Still Water Phases 5 and 6 Final Plats 2000 West Parkview Drive

#### **Still Water Subdivision Phase 5**

#### Still Water Subdivision Phase 6

OWNER/DEVELOPER WOODSIDE HOMES OF UTAH LLC 460 WEST 50 NORTH #200, SALT LAKE CITY, UTAH 84101 (801) 869-4000 CONTACT: GARRETT SEELY OR DEREK TERRY

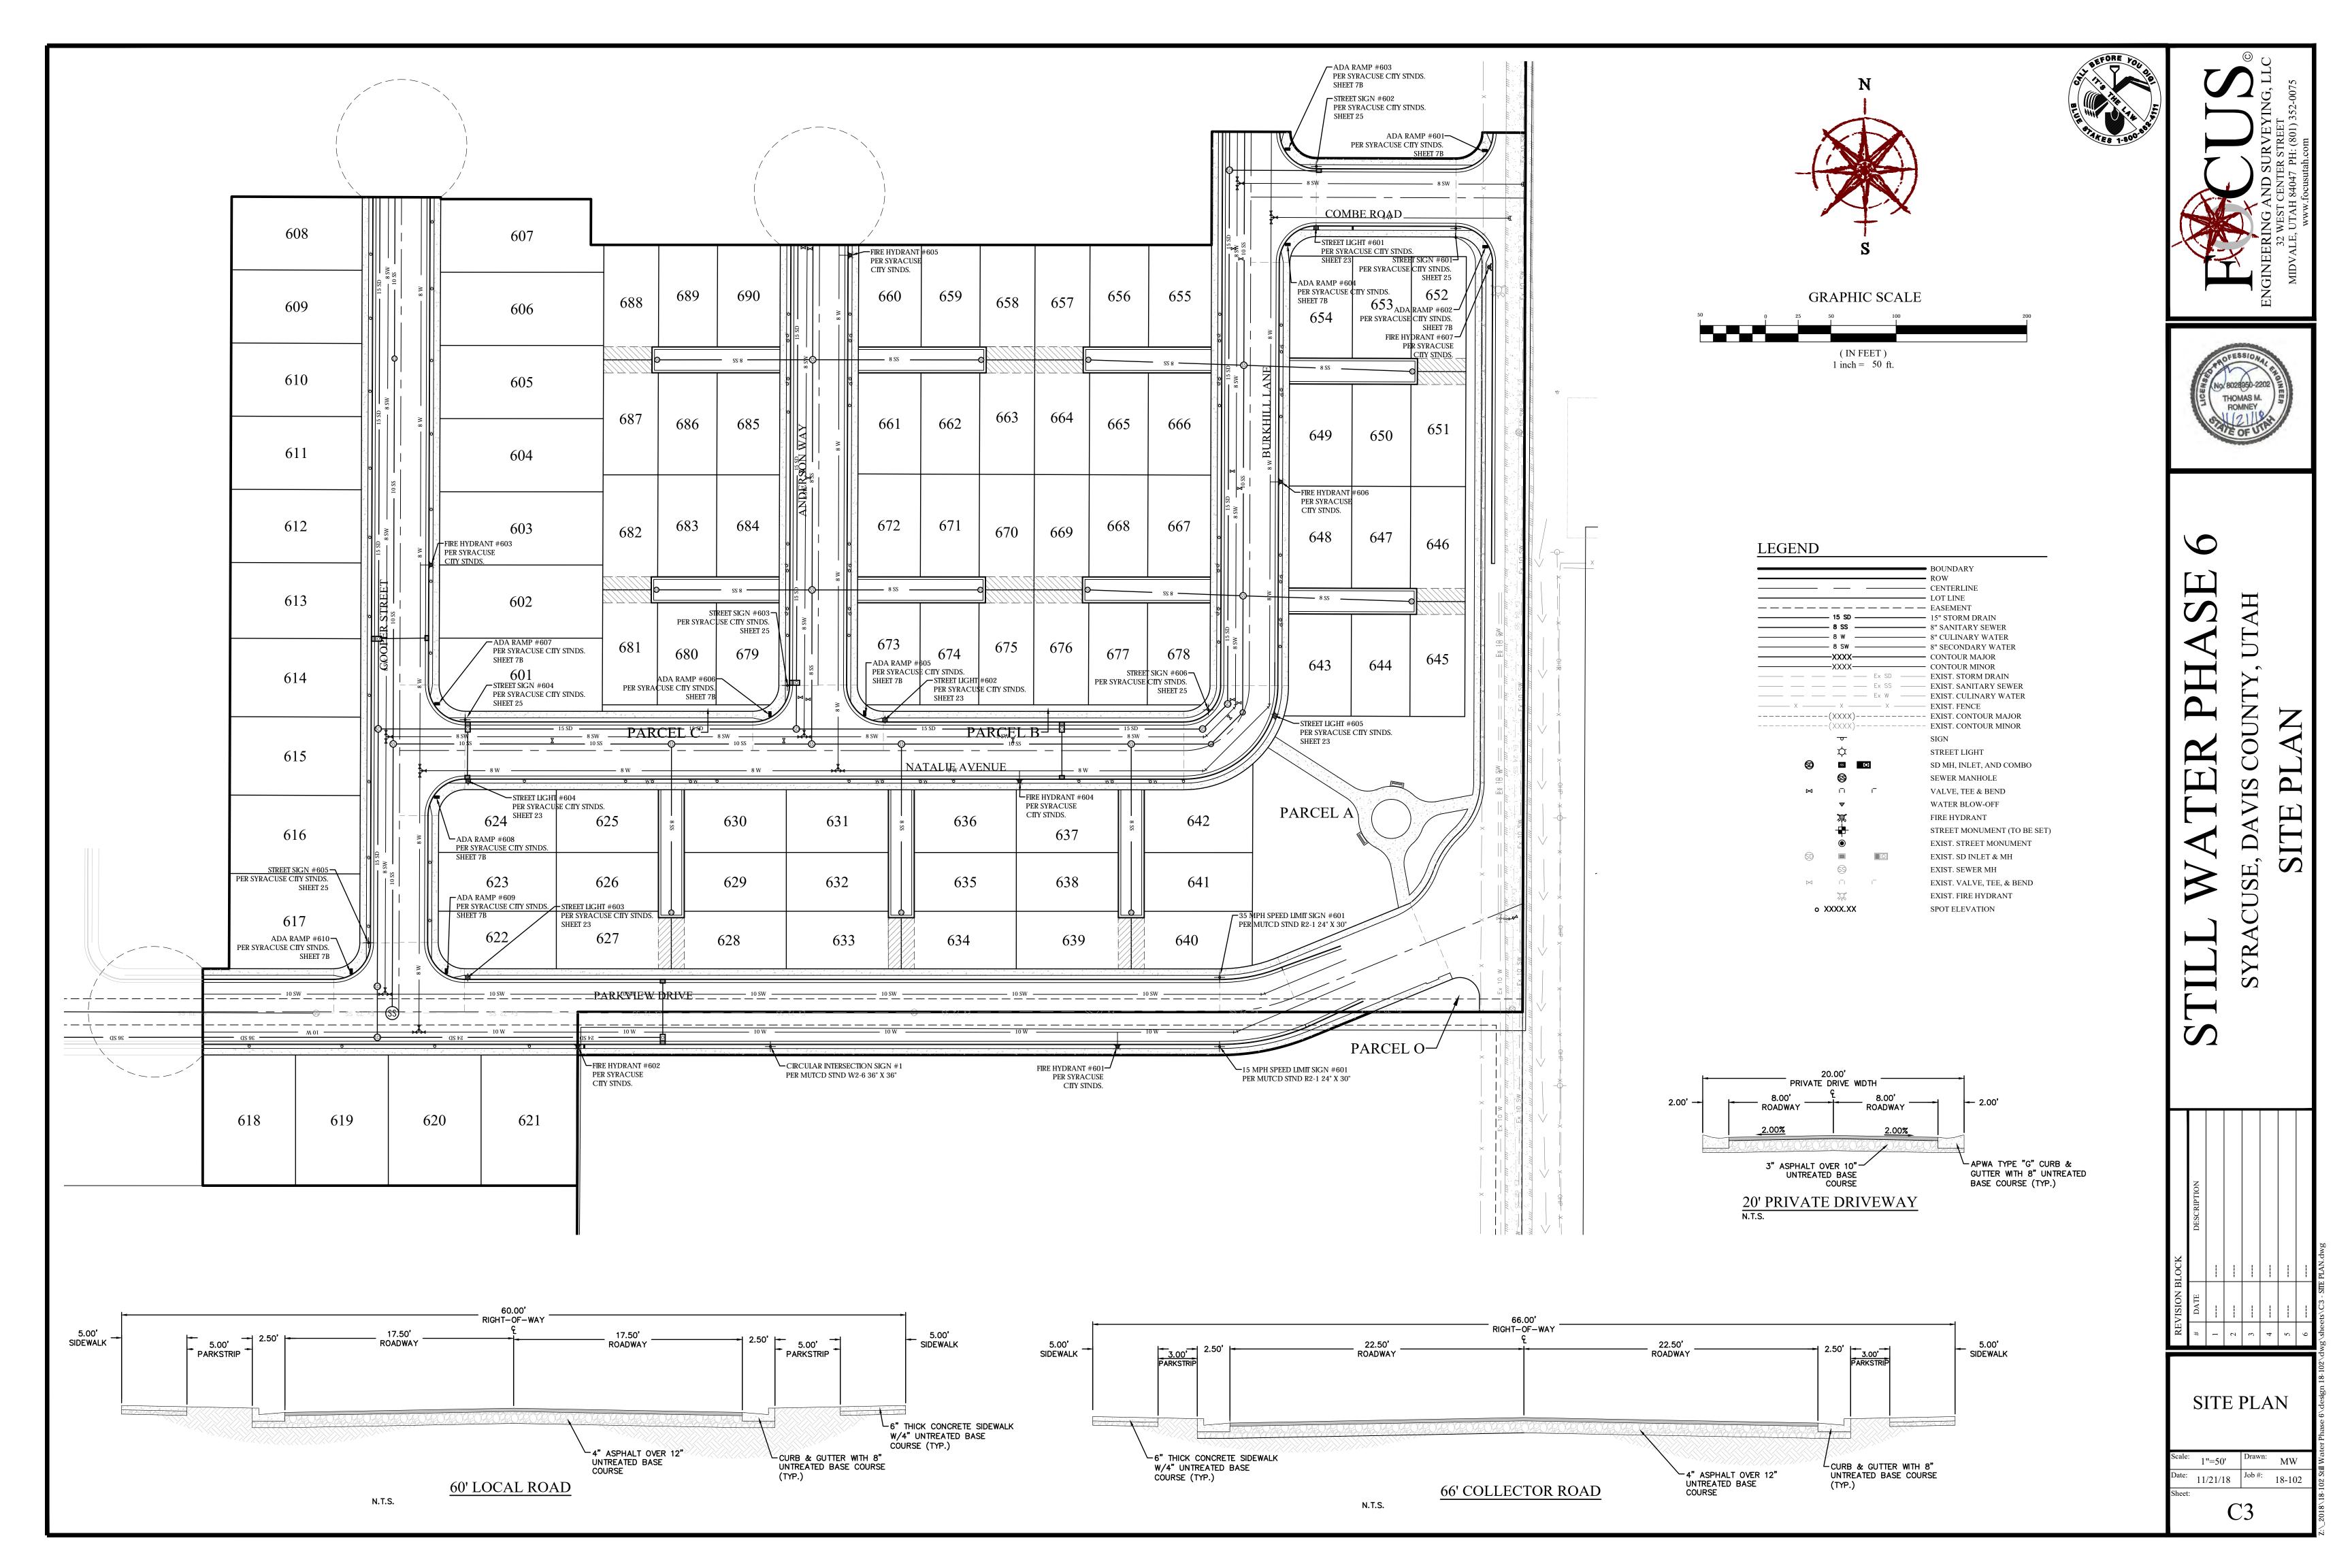
- The School District property will need to be dedicated to the City for Parkview Drive & 2000 West Street.
- 2. The owner's dedication and Note 6 conflict.
- 3. Dedicate a public utility easement over Parcel O.
- 4. Update the owner's dedication to reflect this phase.
- 5. There are two Parcel G's shown.

- 1. North Davis Sewer District shall be contacted for approvals for all connections to their main.
- 2. All valves shall be gate valves. Butterfly valves are not permitted.
- 3. Add a street light between Lots 633 and 634.
- 4. The street signage on Parkview Drive around the round about shall match what was installed with the other 3 legs.
- 5. Per the development agreement, the existing culinary and secondary waterlines shall be upsized to 10" lines from 3350 South to 3000 South Street with this phase.
- 6. All inverts in on sewer manholes shall be the same with 0.2' minimum drop through the manhole.
